State Significant Development SSD 9575 (Council Reference DA18/0685) - Concept Application, Stage 1 works and SEPP to Amend Tweed LEP 2014 for new Tweed Valley Hospital (NSW Planning & Environment App No. SSD 9575) at Lot 11 DP 1246853; No. 771 Cudgen Road CUDGEN

Annexure 1
MATTERS FOR CONSIDERATION BY THE DETERMINING AUTHORITY

Figure 4.3: Site Access Locations

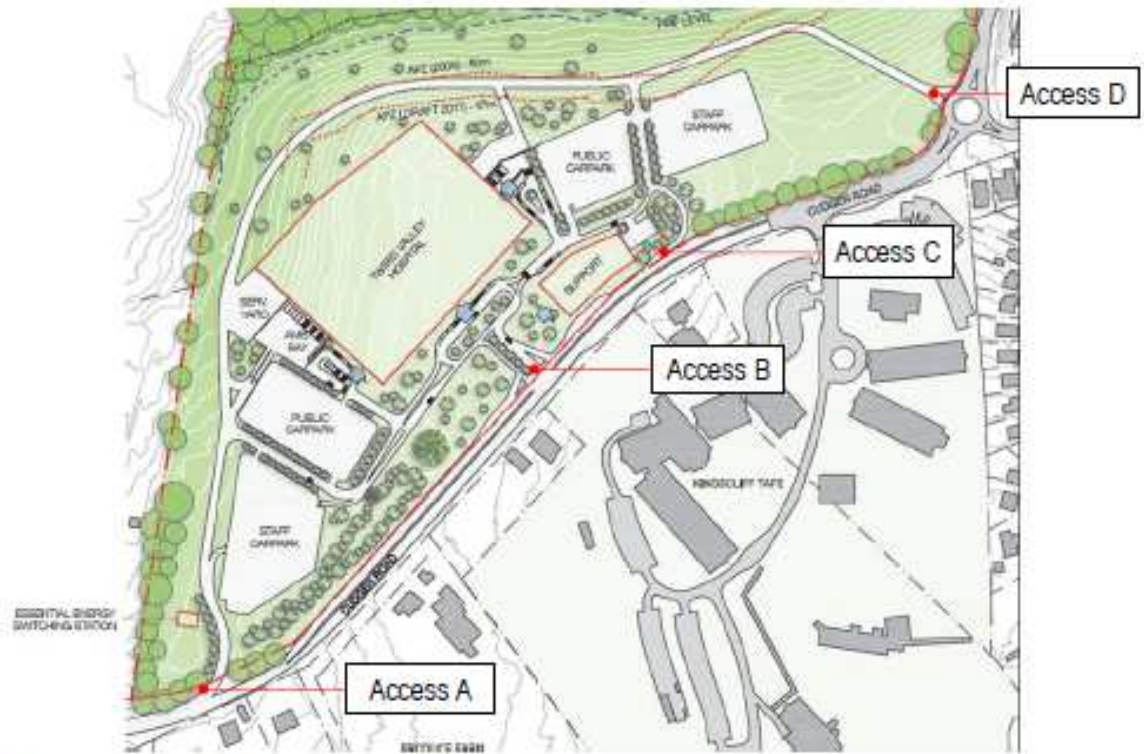
Accesses A and D have also been proposed as “preliminary works”, to be undertaken under Part 5 of the EP&A Act and SEPP (Infrastructure). Council has received initial correspondence in the form of a Notification of Activity seeking consultation on these preliminary works and Council’s requirements. Health Infrastructure will also make application under s138 of the Roads Act seeking approval to undertake works in the road reserve. Refer to specific comments at the end of this assessment report.

Left in only from Cudgen Rd at eastern boundary. The applicant has advised that the western access was designed for use by authorised vehicles only accessing the site via Tweed Coast Road (West). This was used to justify the design of the access to a “higher order treatment” “in accordance with Austroads design and turn warrants.” However, it is noted in the concept design that direct access from this access is provided to the Staff Carpark and this is acknowledged in the Traffic Report on page 45. The report does not identify that the access bisects a shared user path and the potential risks for the existing users of this facility.

It is recommended that should the higher speed access design be pursued then internal access to the Staff and Public Carpark should be removed from this entrance.

All movement access to Cudgen Road/Turnock St by constructing a fourth leg to the existing roundabout.

- G. Access A off Cudgen Road is to be modified to reflect the requirements of Council's Driveway Access Specifications and connect orthogonal to Cudgen Road in a similar configuration to the Byron Bay Hospital access from Ewingsdale Road.***

- H. Access D - The design is to be updated to show a continuous connecting path of travel for pedestrians at the north/west leg of the roundabout on Cudgen Rd.***

Stage 1 Works

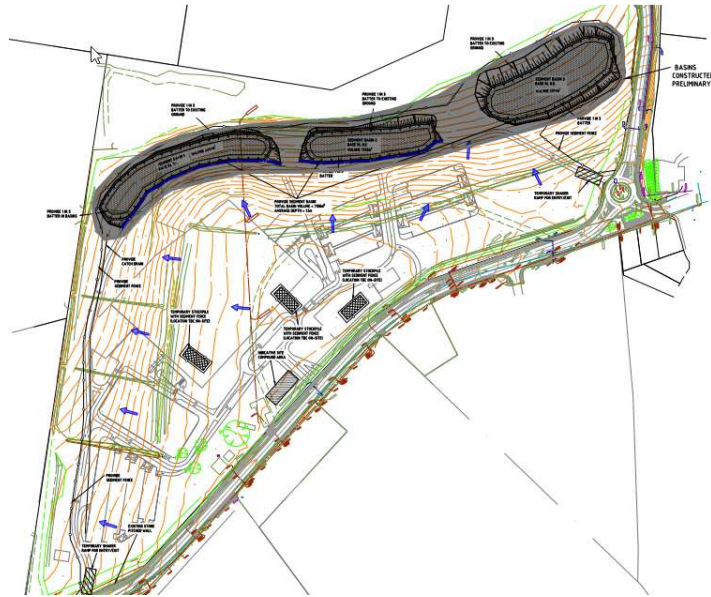
Section 4.5 of the Civil and Structural Design Report outlines the applicant strategy for soil and water management during construction. Key to the strategy are 3 x large sediment basins located towards the north of the site. The report states that: The design of these measures is in accordance with the Landcom “Blue Book”. Refer to drawings C0005, C0006 and C0007 for the Soil and Water Management plan, Typical Detailing and sediment basin volume calculation sheets. However, drawings C0006 and C0007 are not included in the appendices, nor are any sediment basin calculation sheets.

Whilst the proposed erosion and sediment control strategy is acceptable, little detail of the proposed measures is provided. For example, no details of the basin sizing calculations and basin outlet configurations are provided.

The early establishment stormwater works and erosion and sediment control strategy outlined can generally be supported in principle. However, further detail design documentation of the proposed works would usually be required to confirm the acceptability of detailed design. It appears that this opportunity will not be available under the proposed approval pathway.
